16. Staff-Initiated Text Changes

Staff-Initiated Text Changes

This chapter presents changes to the text of the Draft PEIR made in response to comments (as presented in Chapters 14 and 15) or to clarify and provide applicable updates of the text in the Draft PEIR. The text revisions in this chapter represent four main categories of changes: (1) clarifications/refinements made in response to comments; (2) updated information due to WSIP revisions; (3) clarification/refinement due to updated information; and (4) clarifications/corrections made due to editorial errors. Text changes are prefaced by a brief explanation, including where appropriate, reference to the master response in Chapter 14 or comment number in Chapter 15. In each change, new language is underlined, while deleted text is shown in ~~strike through~~, except where the text is indicated as entirely new, in which case no underlining is used for easier reading.

Figure 5.1-2 (Revised)
Annual Average Historical and
Projected Future Customer Purchase Requests

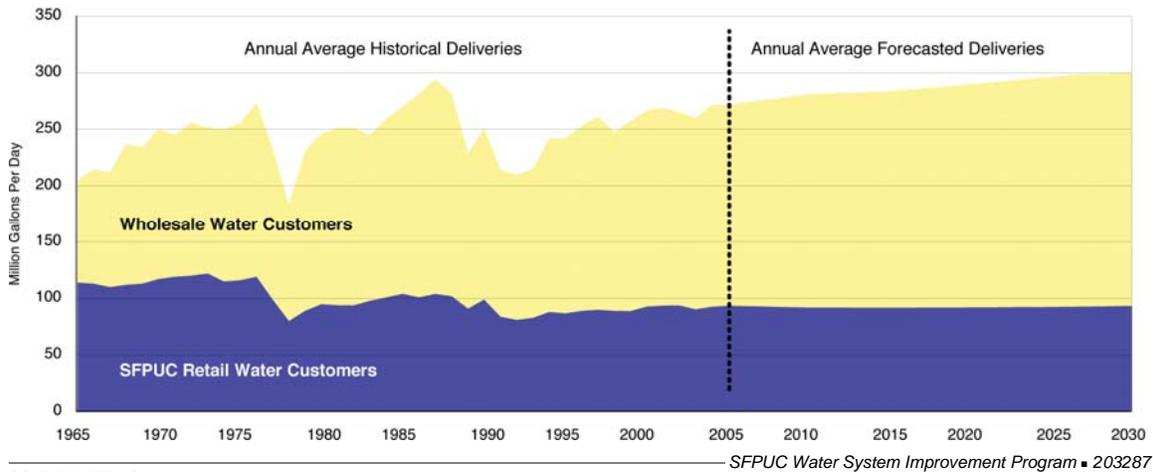
Section 5.1.3, page 5.1-6, Figure 5.1-2: The label on the right-hand side of the figure is revised as shown on the following page in response to a comment (see **Response L_BAWSCA1-57**).

Figure 5.4.1-14 (Revised)
Chronological Operation of San Antonio Reservoir

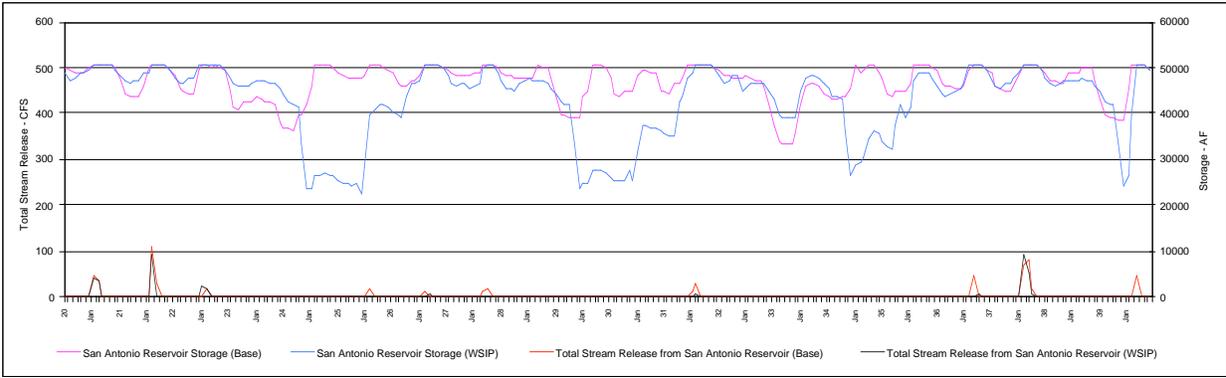
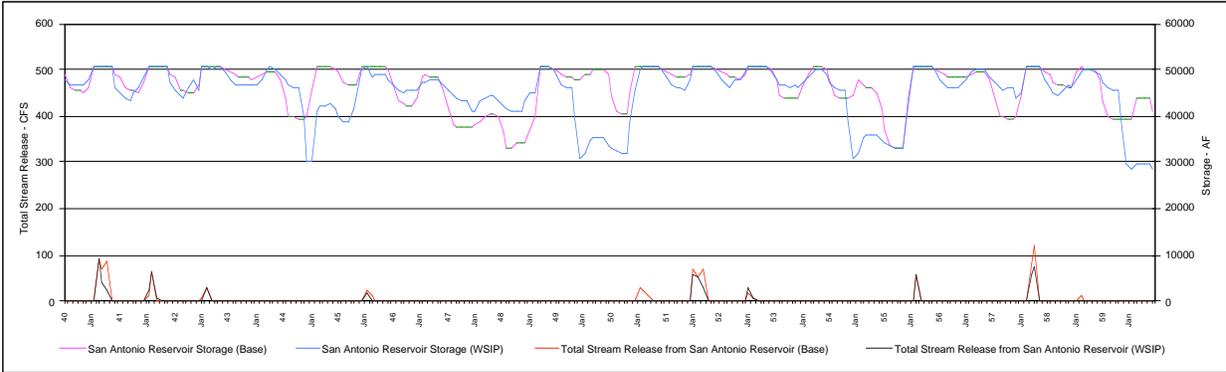
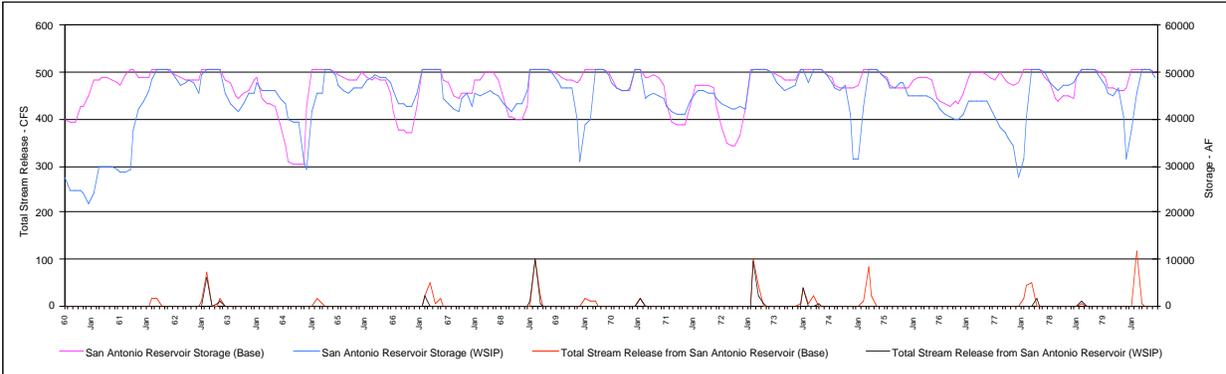
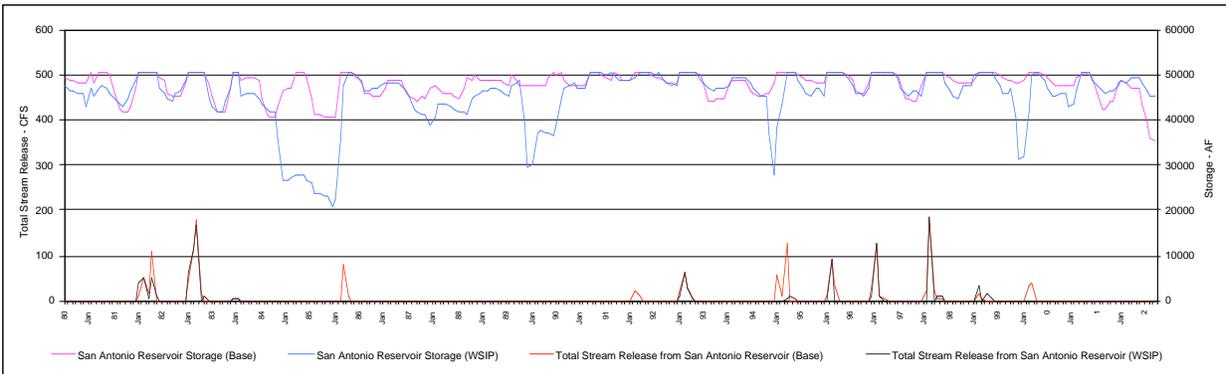
Section 5.4.1.2, page 5.4.1-36: The first and second full paragraphs are revised as follows and Figure 5.4.1-14 (shown on page 16-55) is revised to reflect the updated impact discussion based on the modeling results conducted in 2008, as discussed in Chapter 13, Section 13.3.

Note: This figure is revised to reflect updated HH/LSM modeling (see Appendix O).

Figure 5.5.1-9 (Revised)
Average Monthly Storage Volume,
San Andreas Reservoir

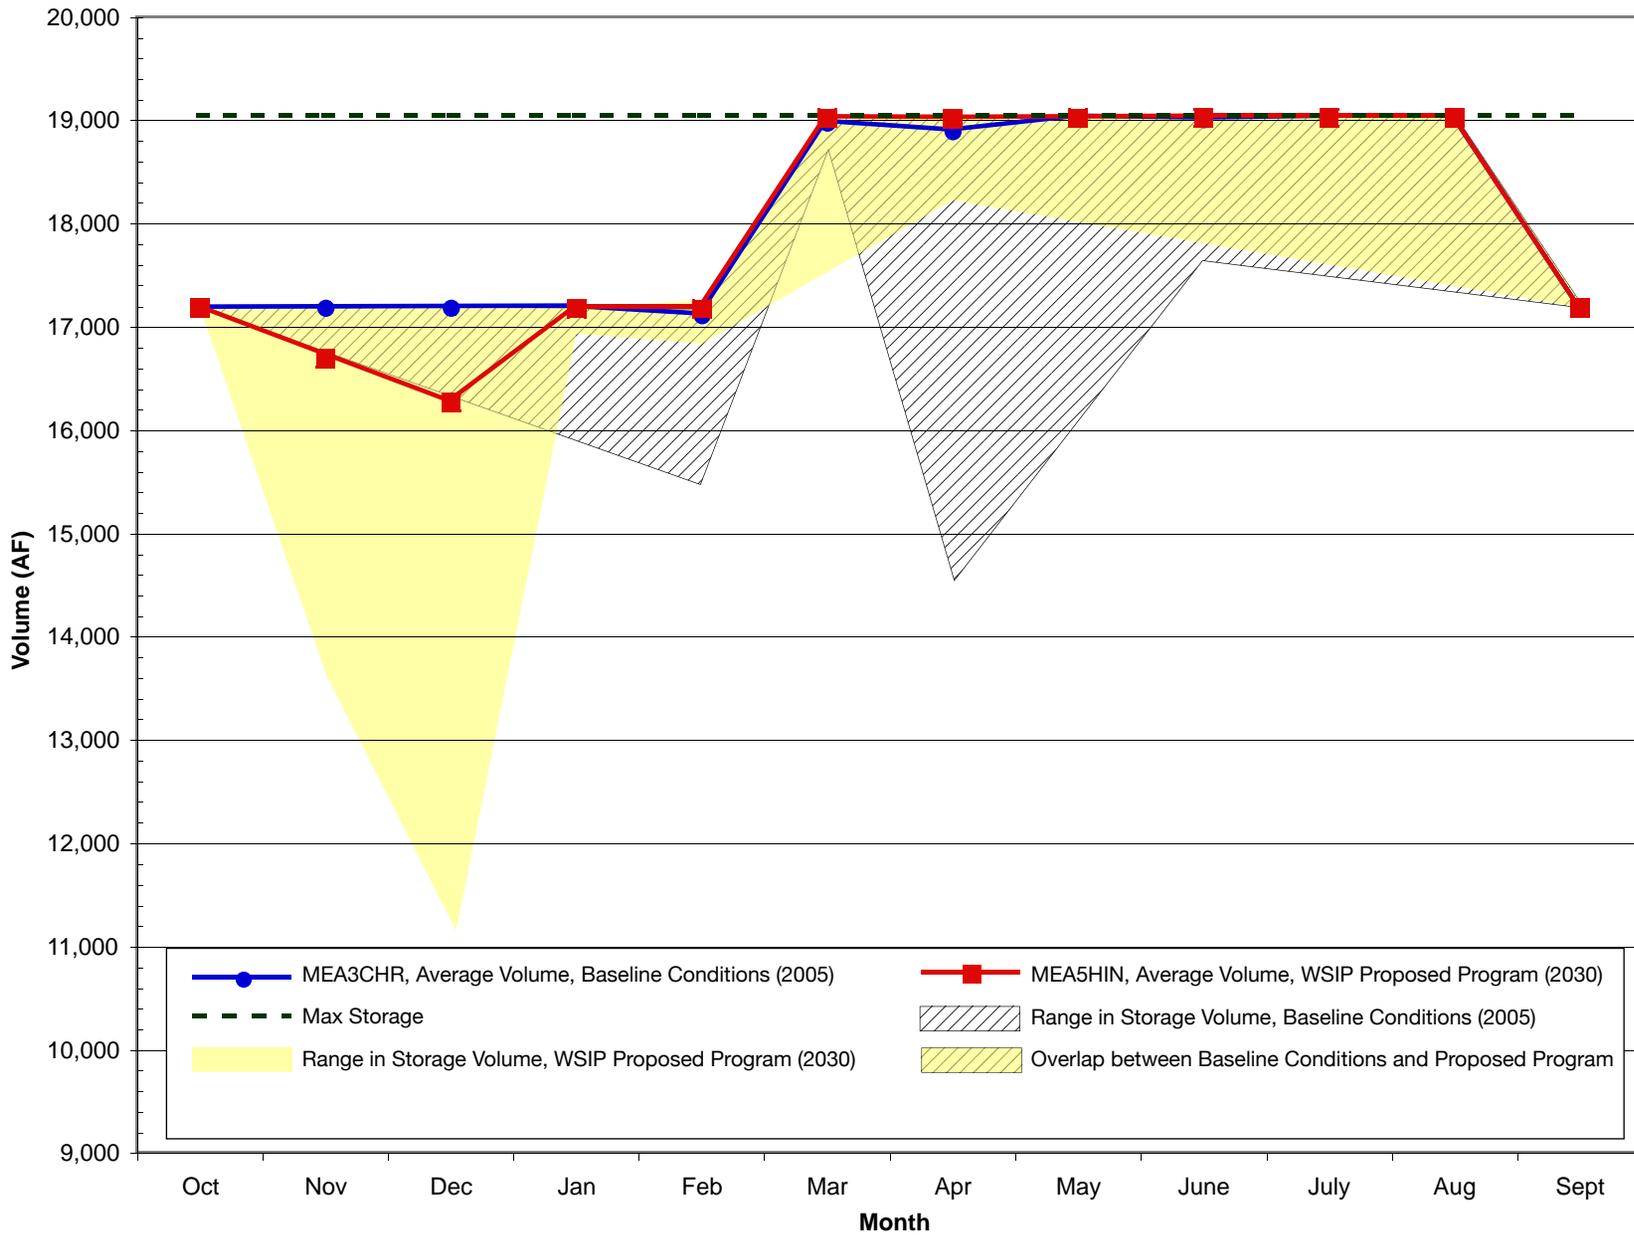
Section 5.5.1.2, page 5.5.1-18: The legend in **Figure 5.5.1-9** is revised to show the correct range in storage volume of the San Andreas Reservoir. The Draft PEIR incorrectly labeled the yellow area as “Range in Storage Volume, Baseline Conditions (2005)” and the hatched area as “Range in Storage Volume, WSIP Proposed Program (2030).” Figure 5.5.1-9 is revised as shown on the following page.

SFPUC Water System Improvement Program . 203287
Figure 5.7-3 (Revised)
 Future Projects in the Alameda Creek Watershed Considered in the Cumulative Analysis

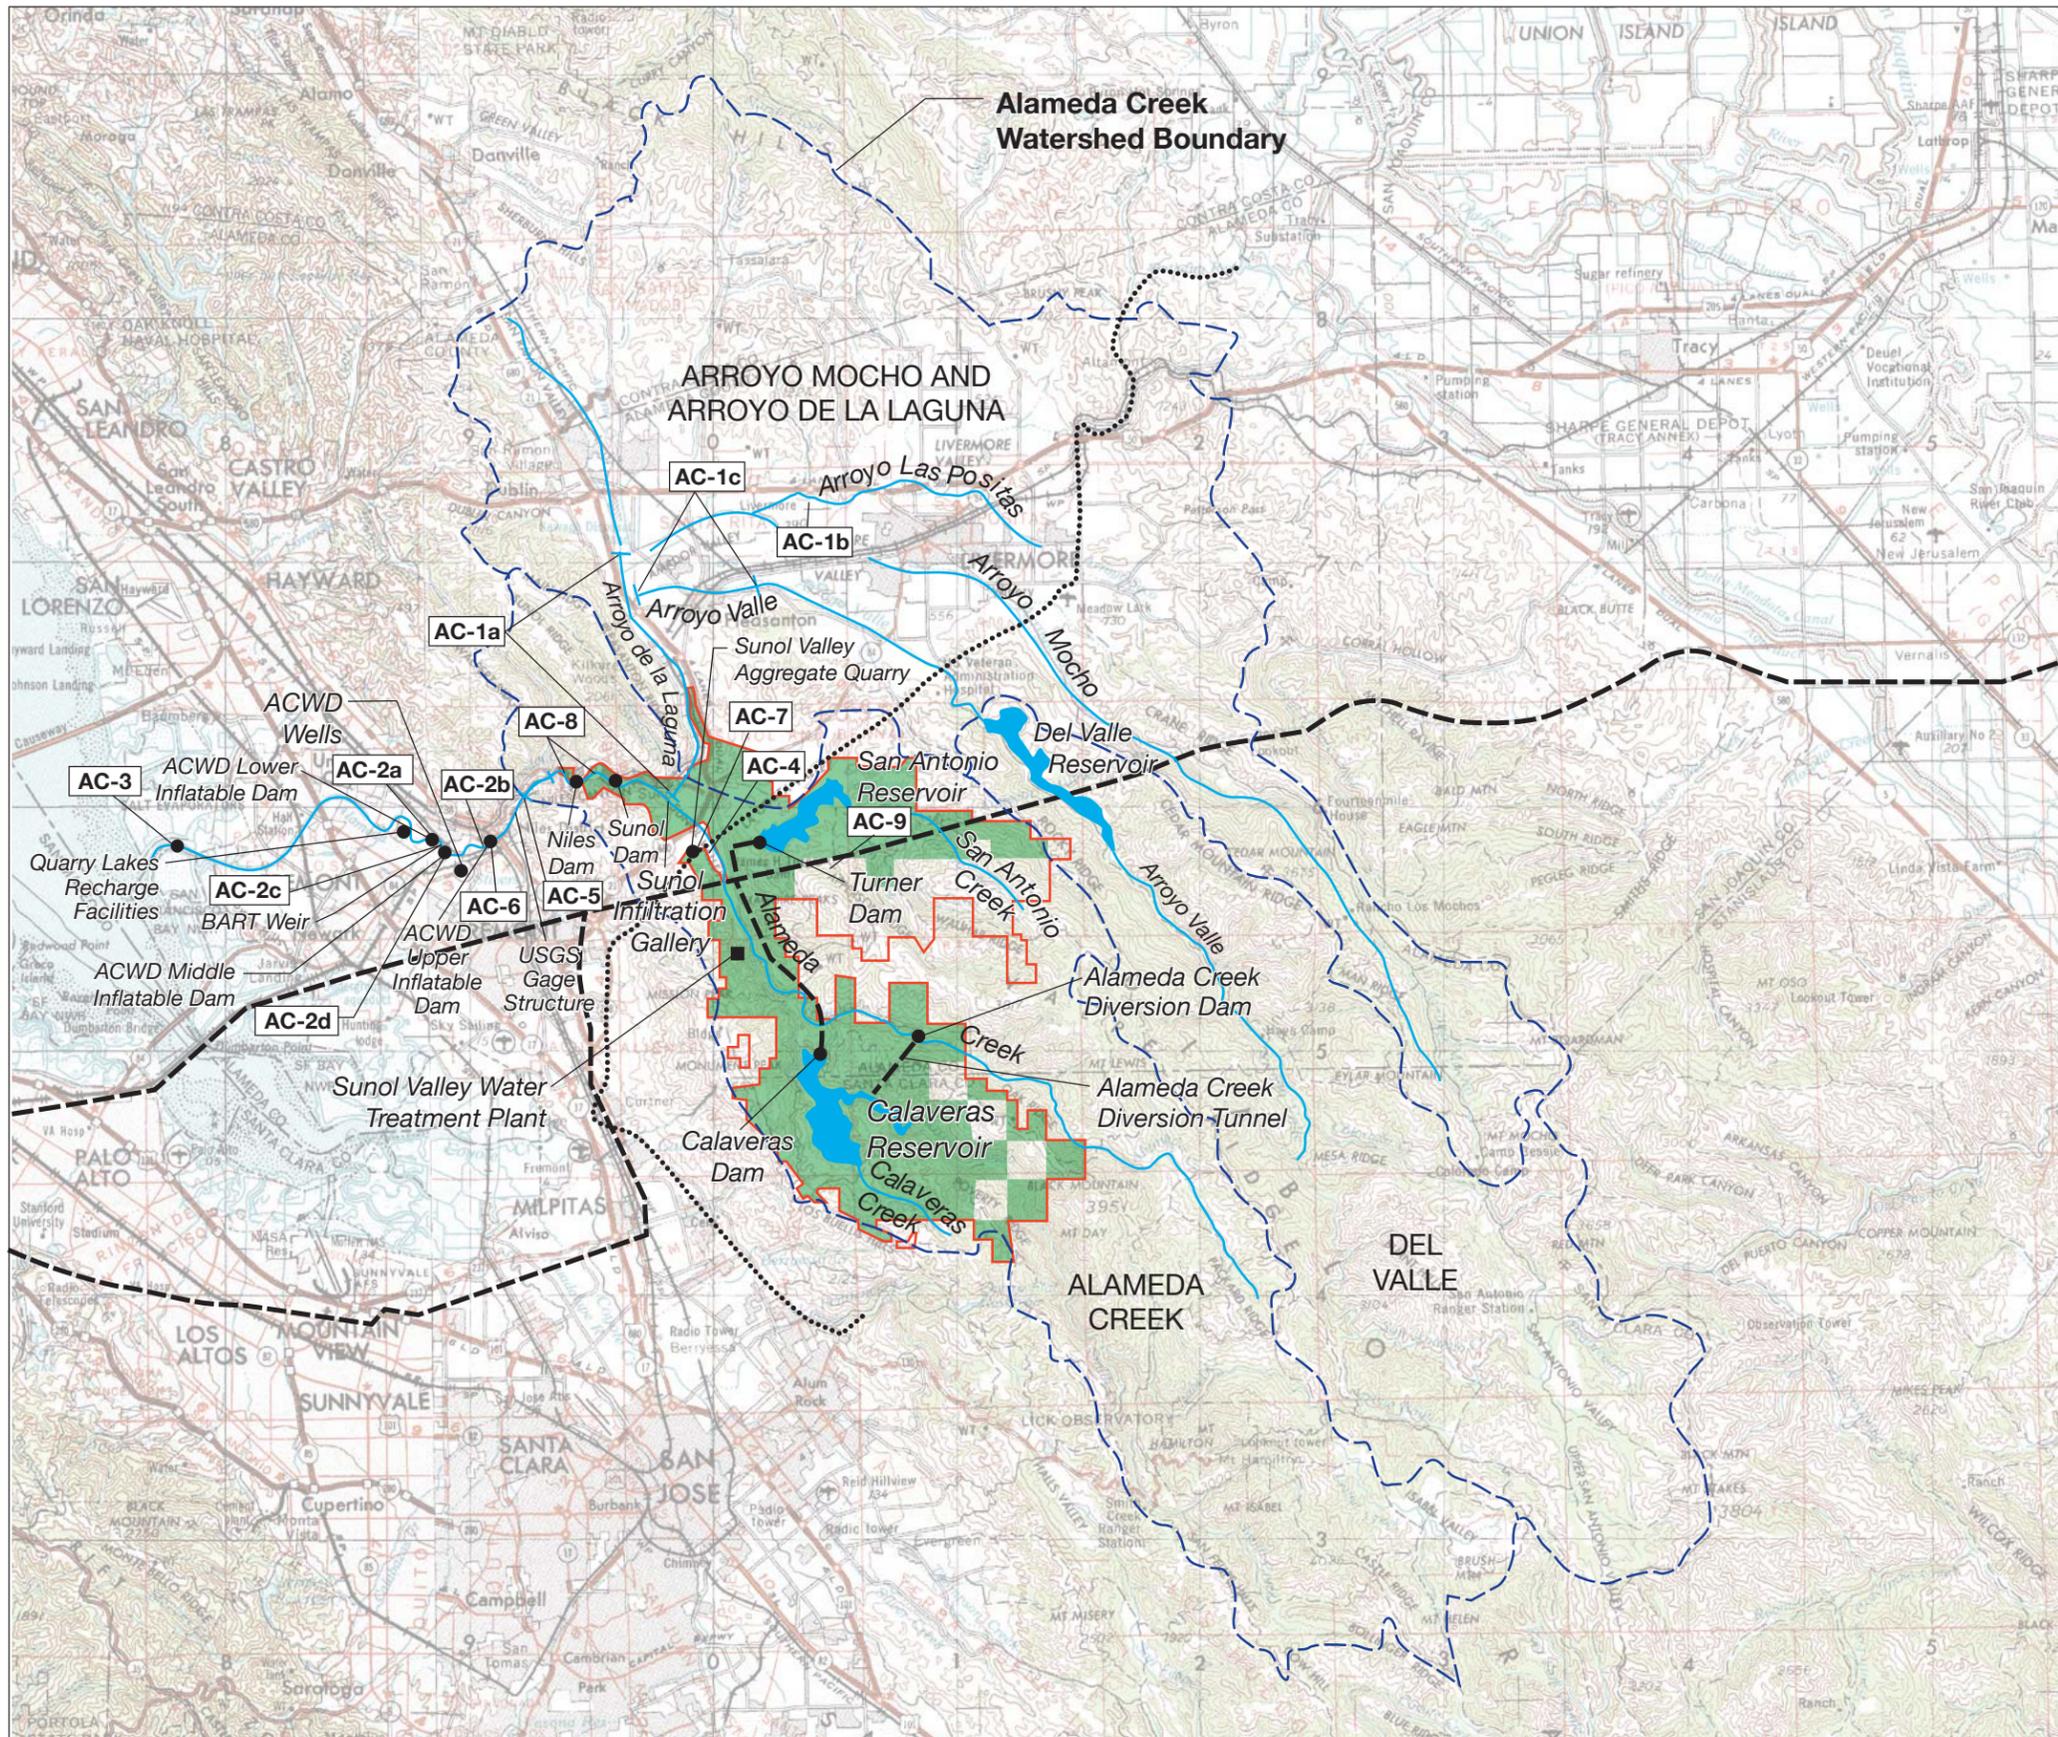
Section 5.7.3.2, page 5.7-55, Figure 5.7-3: This figure is revised as shown on the following page in response to comments described in **Section 14.9, Master Response on Alameda Creek and Fishery Issues.**
